60th Avenue Standpipe
 1015 60th Ave SW
 Cedar Rapids, IA 52404

Boyson Tank
 575 Boyson Rd. NE
 Cedar Rapids, IA 52402

Mt. Vernon Tank
4328 Mt. Vernon Rd. SE
Cedar Rapids, IA 52402

**J Avenue Water Treatment Plant -
Lime Sludge Tank
761 J Ave NE
Cedar Rapids, IA 52402**

GENERAL ELEVATION
 60'-0" ID X 92'-4" HIGH DRT
 CITY OF CEDAR RAPIDS, IOWA

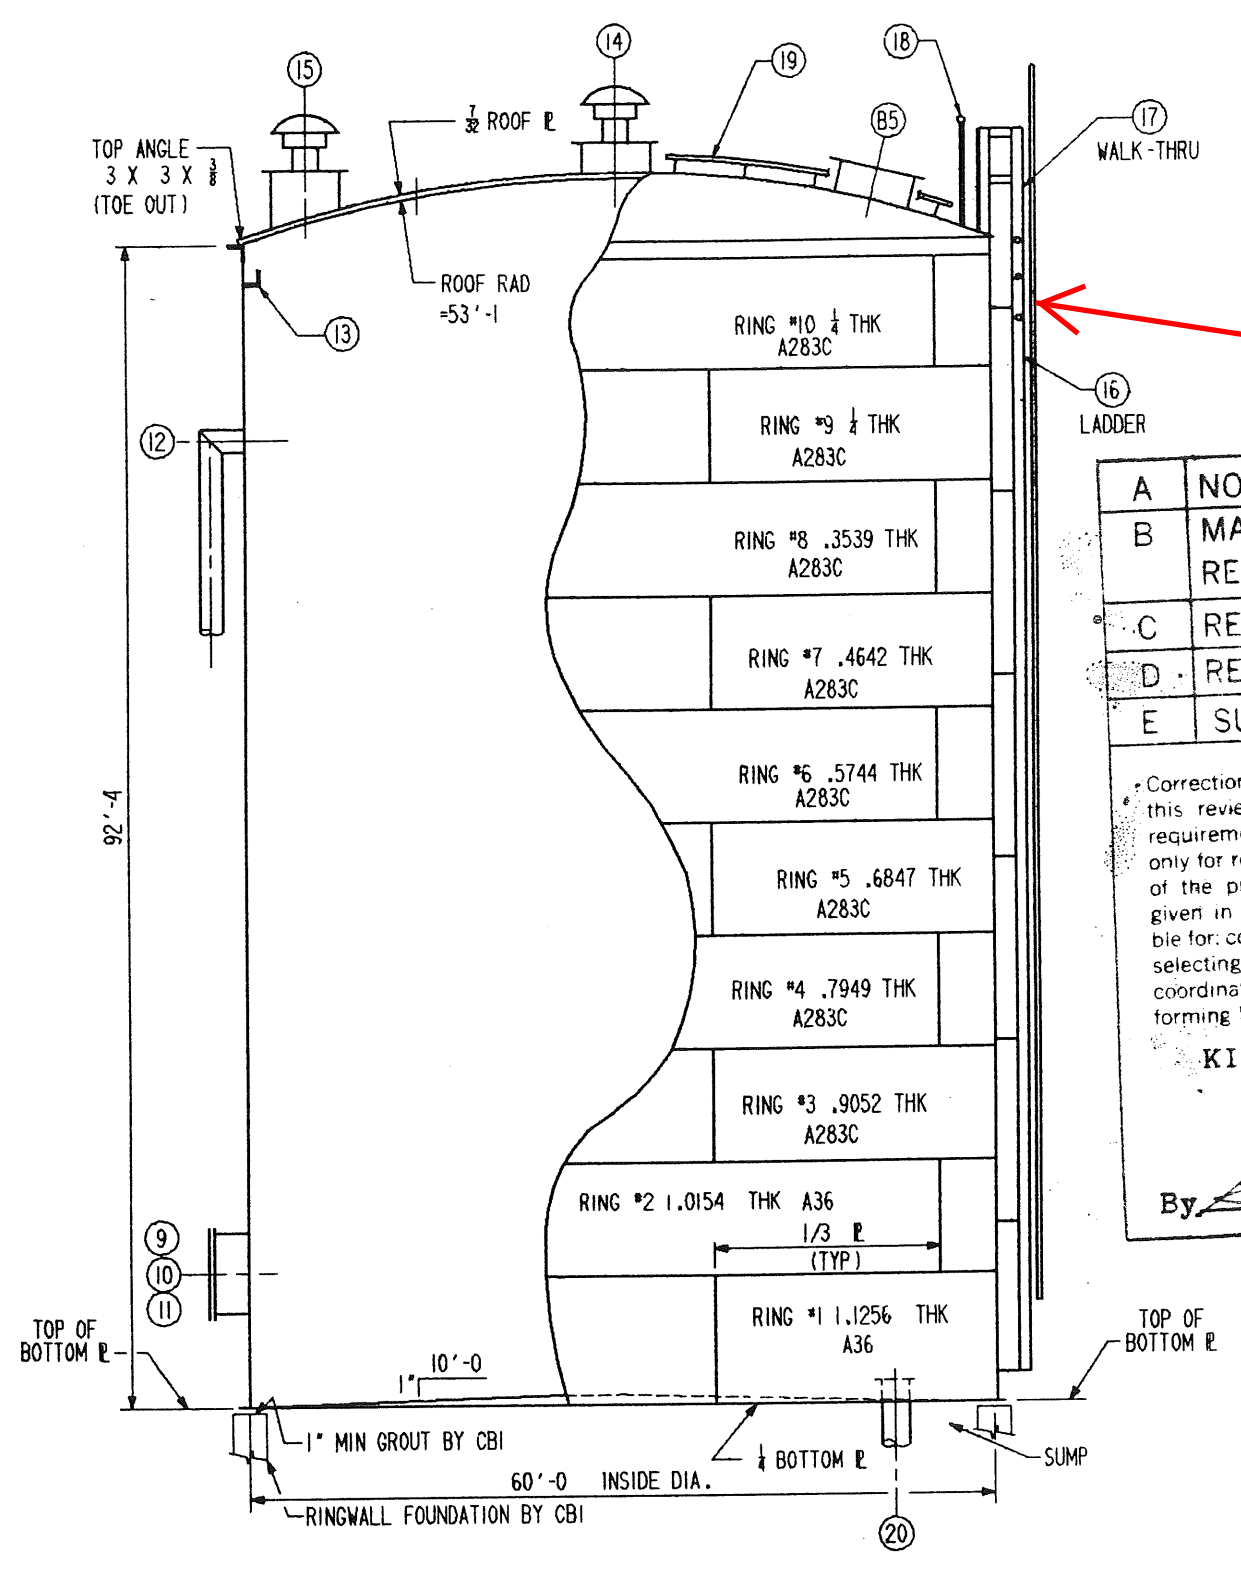
Replace existing pipe rail with cable style fall protection system on exterior ladder.

PITTSBURGH, INC. ENGINEERS - FABRICATORS - CONTRACTORS	
BOYSON ROAD TANK 3000 GAL. HYDROPILLAR CEDAR RAPIDS, IA MAIN ERECTION	
DATE PREPARED AT	DATE INDICATED AT
BY	DATE
DRAWN: MB	5-16-89 DRAWING: E-1
CHECKED: PB	4-22-89 CONTRACT: E9016

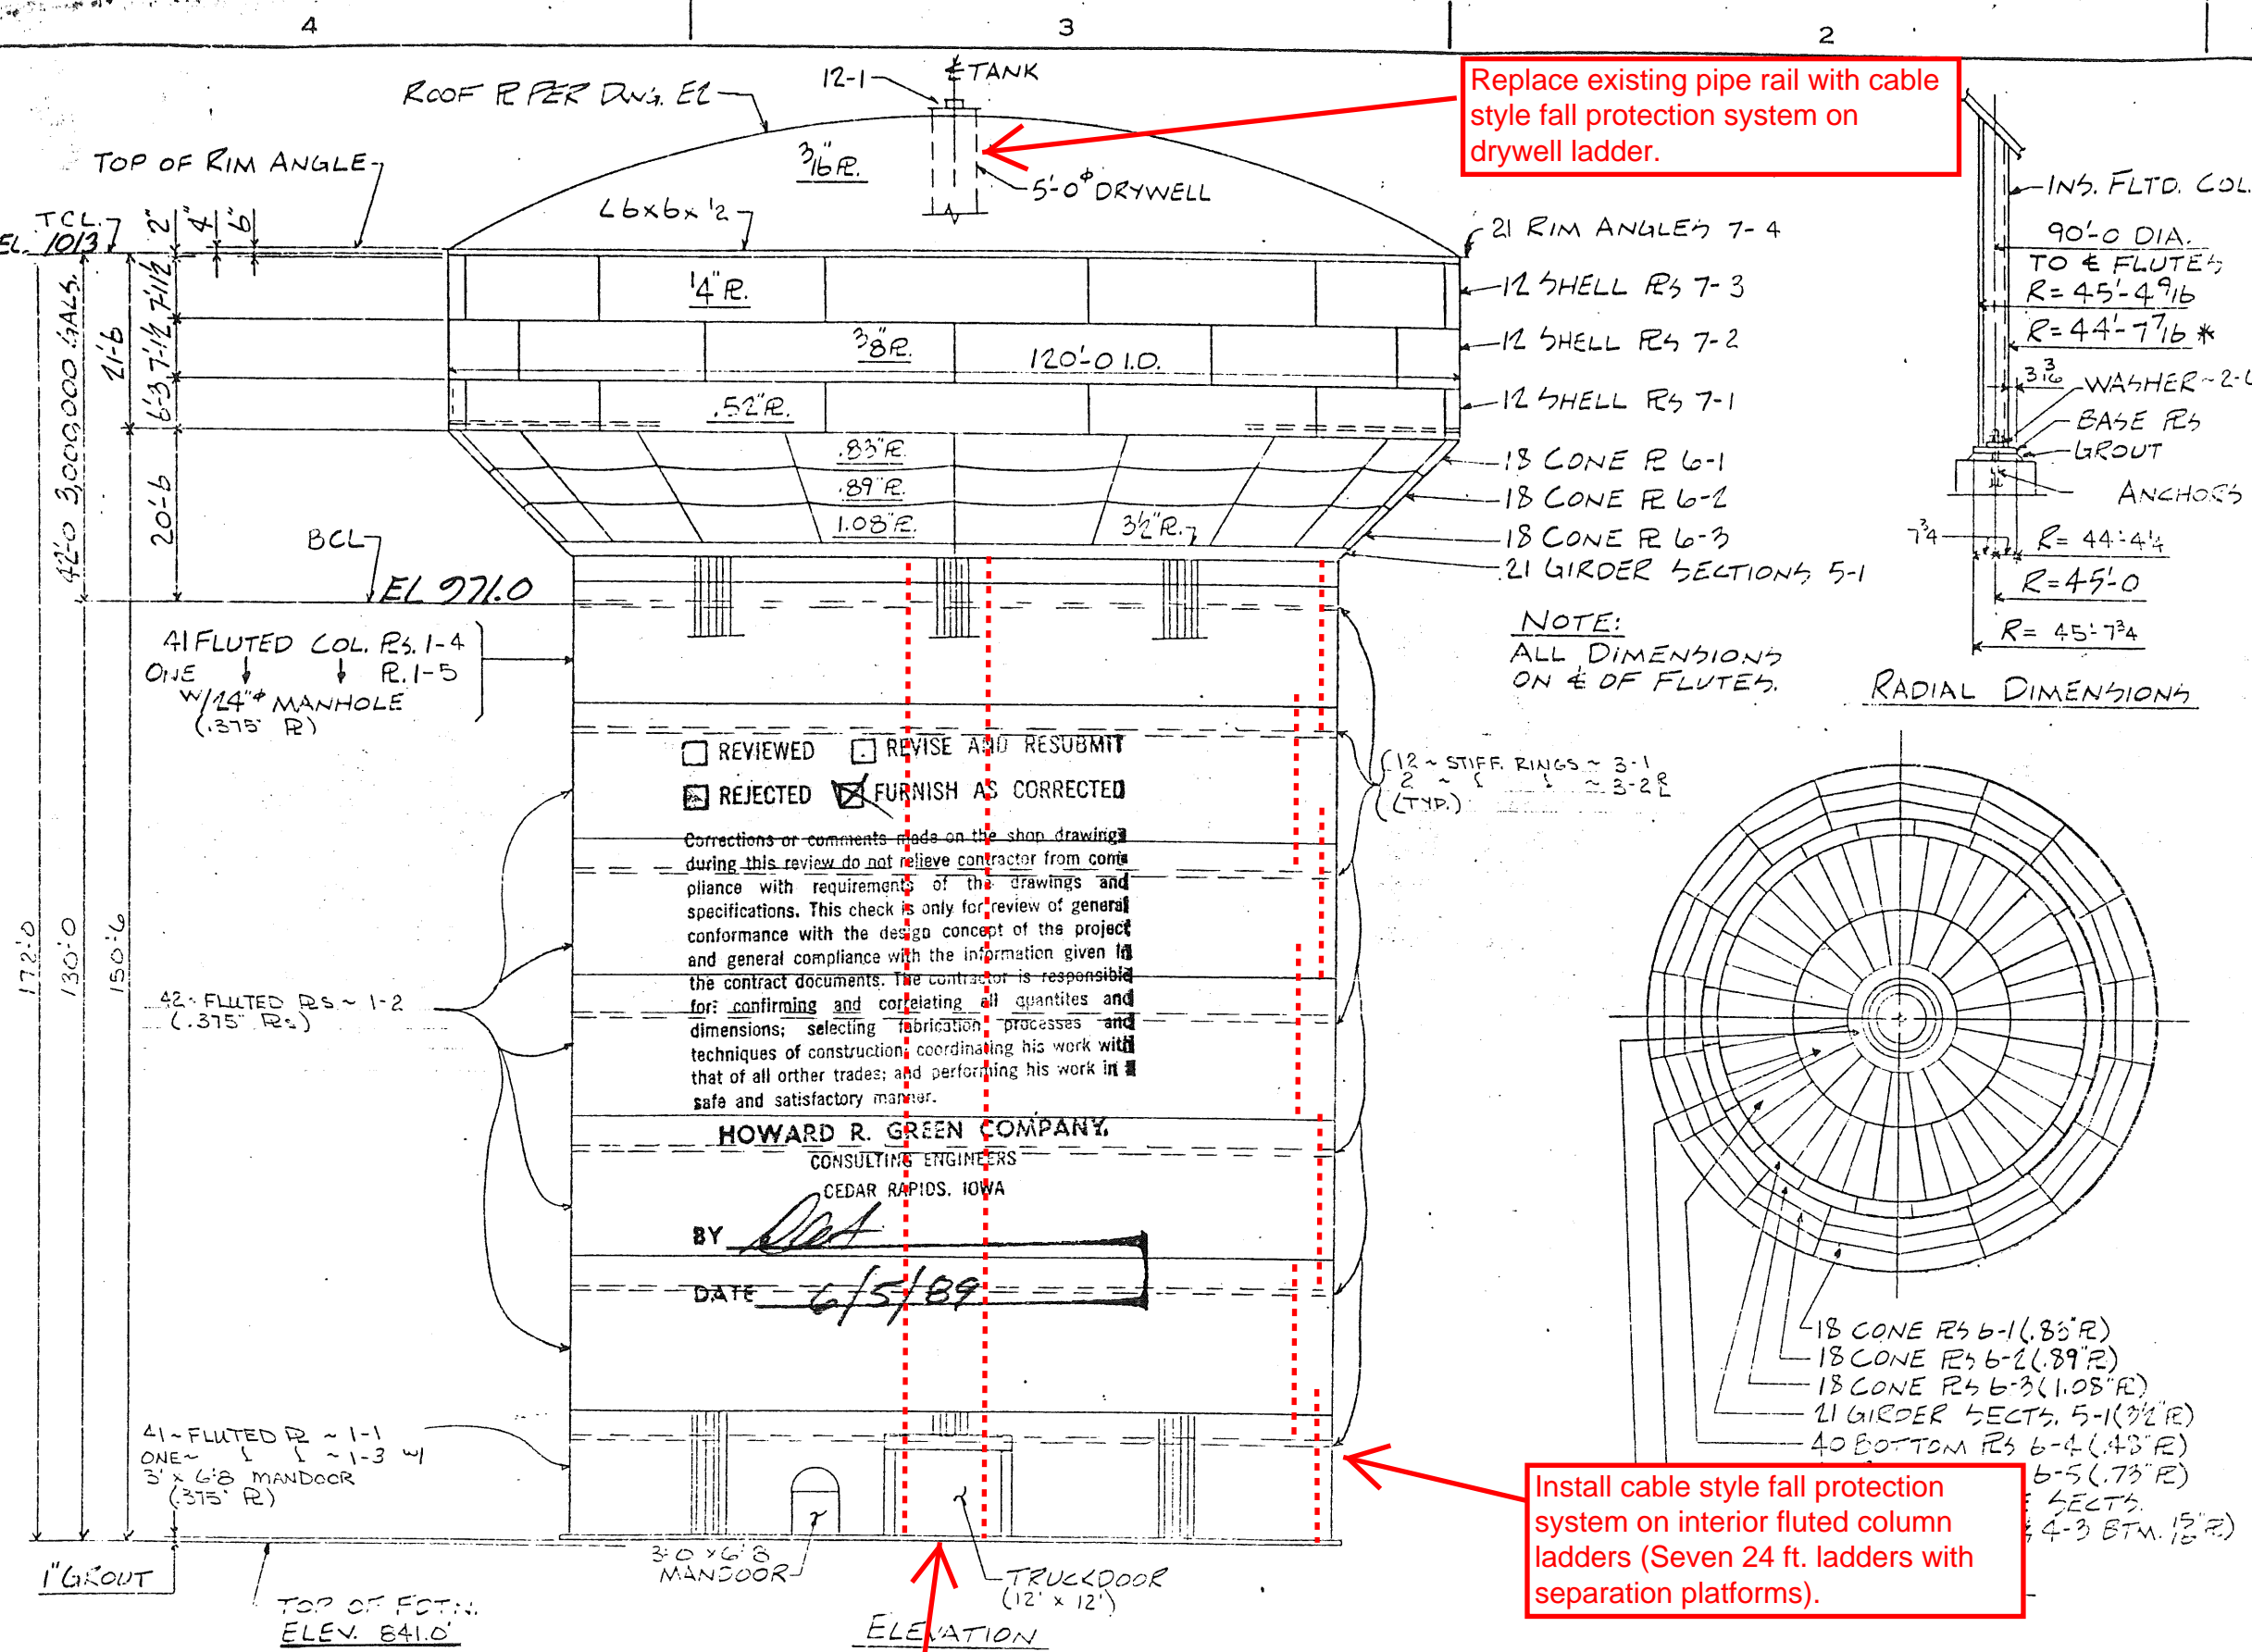
Replace existing pipe rail with cable style fall protection system on drywell ladder.

Install cable style fall protection system on interior fluted column ladders (Seven 24 ft. ladders with separation platforms).

Replace existing pipe rail with cable style fall protection system on center column ladder.

1000M Gal. Tank Spherical T&T
Cedar Rapids, Iowa
Erection

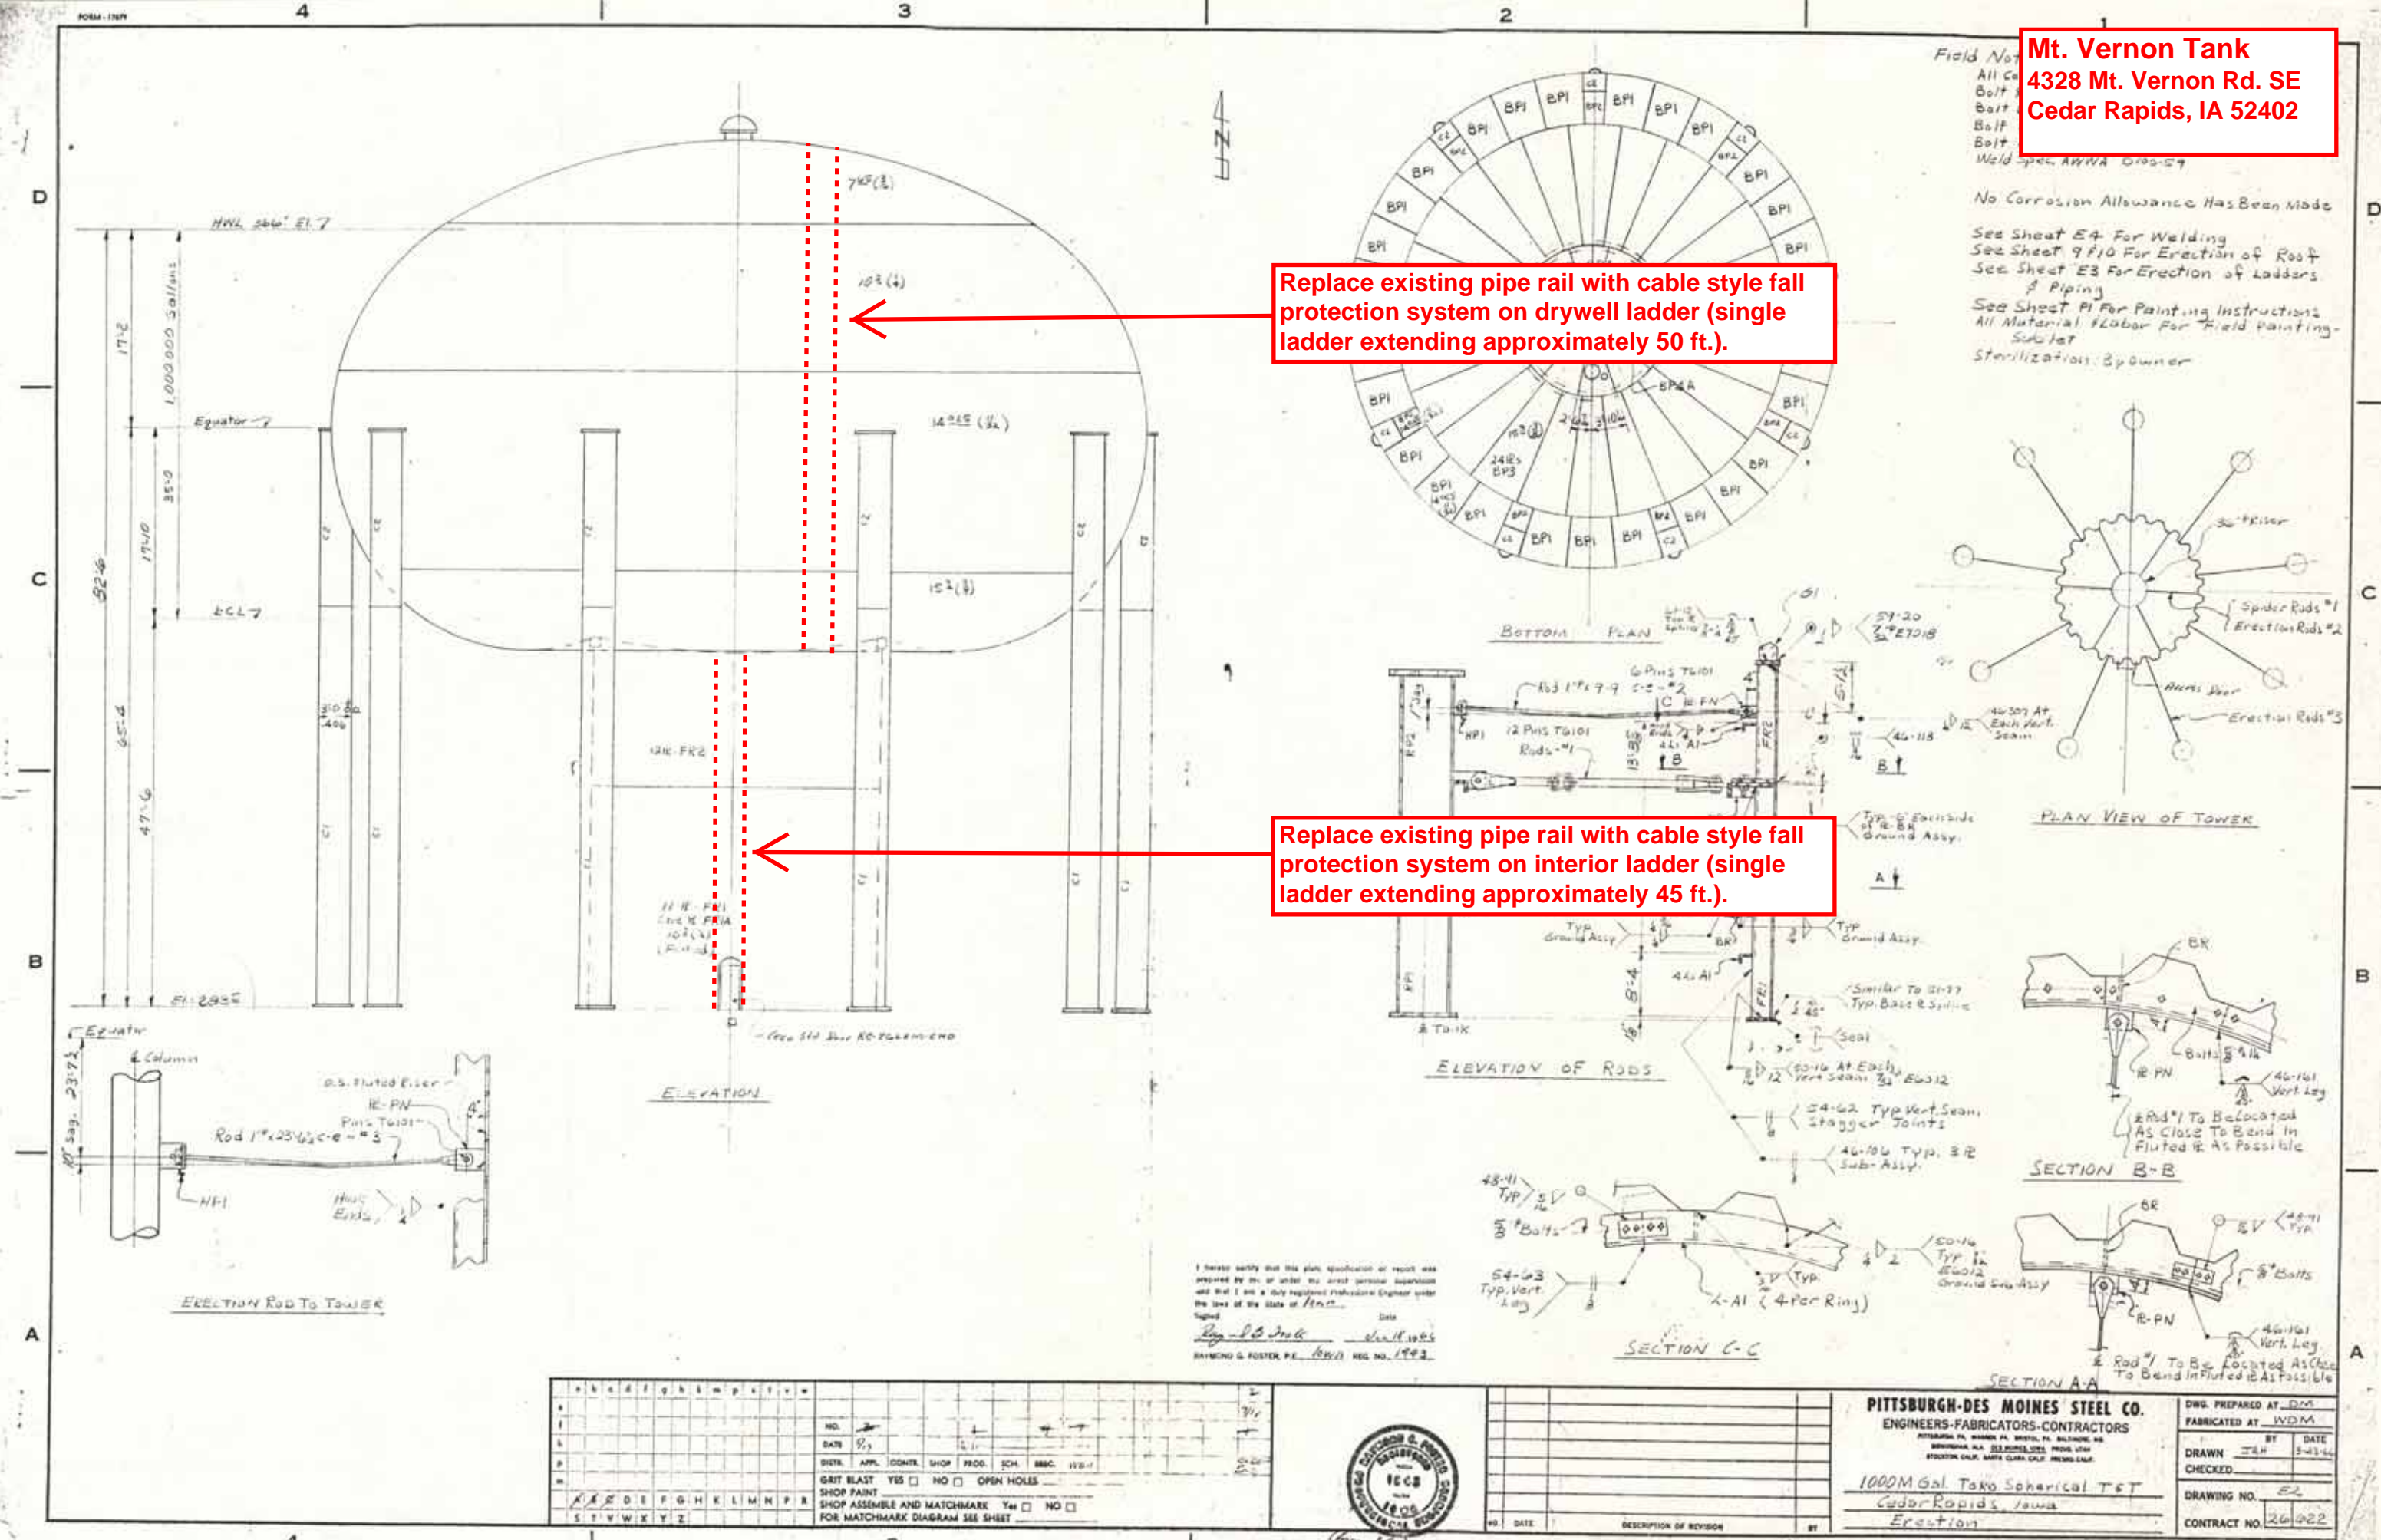
Replace existing pipe rail with cable style fall protection system on drywell ladder (single ladder extending approximately 50 ft.).

Replace existing pipe rail with cable style fall protection system on interior ladder (single ladder extending approximately 45 ft.).
